UNITED STATES PATENT AND TRADEMARK OFFICE

APPLICATION NO.	FILING DATE	FIRST NAMED INVENTOR	ATTORNEY DOCKET NO.	CONFIRMATION NO.
09/670,661	09/27/2000	Lawrence W. Miller	104041-1	7892

Office Action Summary

Detailed Action

Fig.A

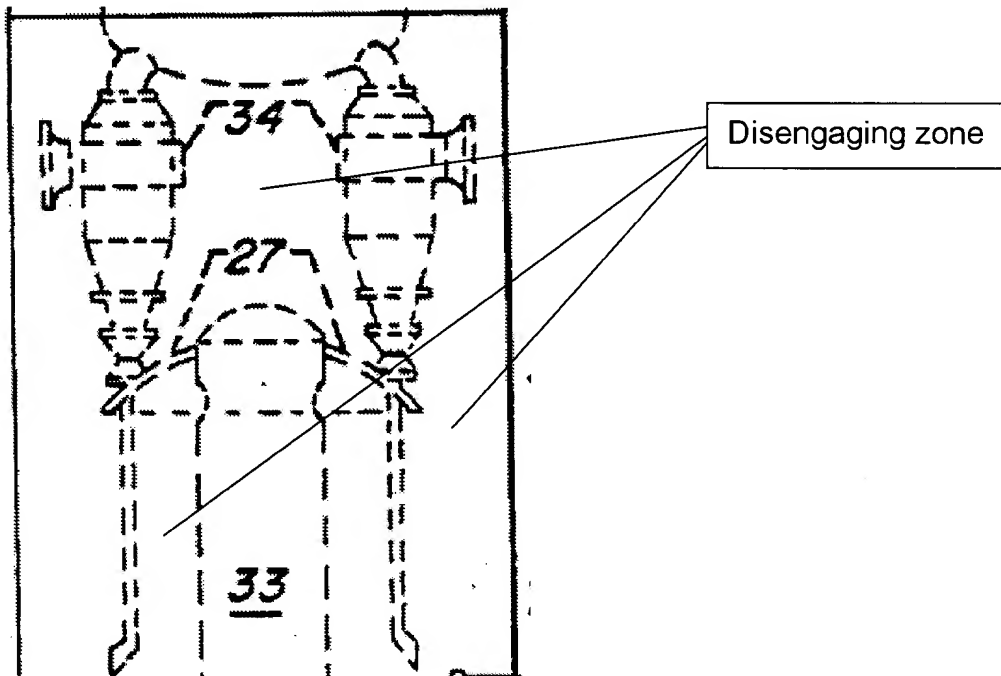
- A **reaction vessel** (Fig. 2, entire image) defining a **disengaging zone** (Fig. A),

a **lower subadjacent reaction zone** (also a dense phase zone) (Fig.2, item 25), a **product outlet** (Fig. 2, item 36) for withdrawing the product stream from the disengaging zone, and a **feed inlet** (interface between Fig.2, items 22 and 24) communicating with the lower reaction zone; (Per the applied prior art, Examiner notes that in Cabrera et al, item 22 is identified as a mixing riser, but functions to transport feed into lower reaction zone (dense phase zone).

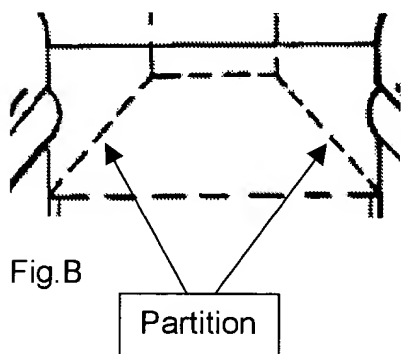
- a **partition** sealingly disposed about an intermediate portion of the reaction vessel to segregate the reaction zone from the disengaging zone (Fig.B)

- a **riser** (Fig. 2, item 33) extending vertically within the reaction vessel from the reaction zone into a central section of the disengaging zone, in fluid communication with the reaction zone, for conducting the product stream and fluidized catalyst particles and defining a discharge opening within said disengaging zone for discharging the product stream and fluidized catalyst particles, said discharge opening being tangentially oriented for imparting a tangential velocity to the product stream and fluidized catalyst particles (see Fig.C);

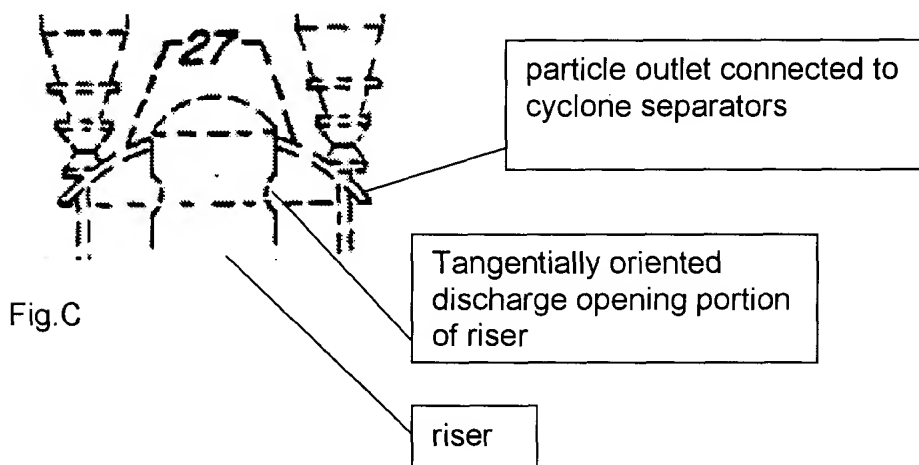
- a separation vessel (Fig.2, item 27) disposed over said riser in the disengaging zone and surrounding said discharge opening to separate gaseous products from fluidized catalyst particles, said separation vessel having a lower portion defining a particle outlet for discharging fluidized catalyst particles and said separation vessel defining a gas recovery outlet for withdrawing gaseous fluids from the separation vessel; (Per the relied upon prior art, Examiner interprets "riser outlet 27" as a separation vessel since said "riser outlet" separates gas and catalyst C13/L44-46. Additionally, since the riser outlet passes catalyst particles into cyclone separators, a

particle outlet is necessarily present for without it there can be no physical interface with said cyclone separators. Fig.C illustrates the relied upon prior art's particle outlet:
